# Village of Bellows Falls/ Town of Rockingham

Town Hall, Public Library, Public Safety Building

## Accessibility Evaluation

March 18, 2016

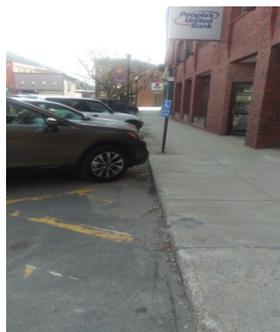
One angled parking space is designated “accessible” with low signage (40”) on the south side of the alley already mentioned, and another is directly across the square.

A sign, mounted 60” above the road surface (so that it can’t be obstructed by a parked vehicle—or snow banks) should identify accessible parking, and bear the universal symbol of accessibility. (The use of pejorative qualifiers, such as “handicap” or “disabled” is considered in poor taste and offensive. A sign indicating “reserved” or “accessible” parking, and bearing the universal symbol of accessibility, is preferred.)

No striped *access aisle* serves either of these designated accessible spaces.

In this instance, the necessary access aisle at the designated accessible angle parking space can be created by designating the adjacent parking space the accessible space, and striping the present space as the access aisle. In a designated van-accessible space, the access aisle should be on the passenger side.

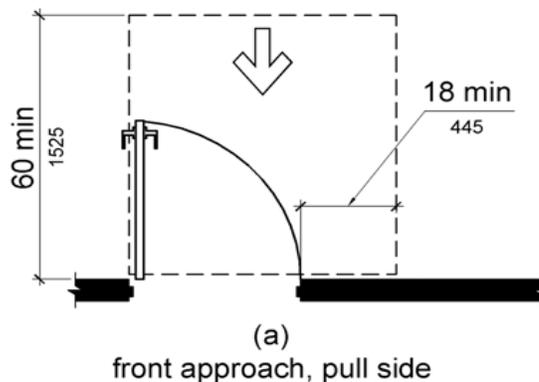
The men's room shares certain similarities with the neighboring ladies' room: with non-compliant door closing speed and pull pressure. In addition, the in-swinging door has no clear space on the pull or latch side of the door: this means a user in a wheelchair can not position himself outside of the arc of the opening door, making it very difficult to exit the room. At least 18" clear space is required (24" is preferred) beyond the latch side of the door to permit this maneuver.
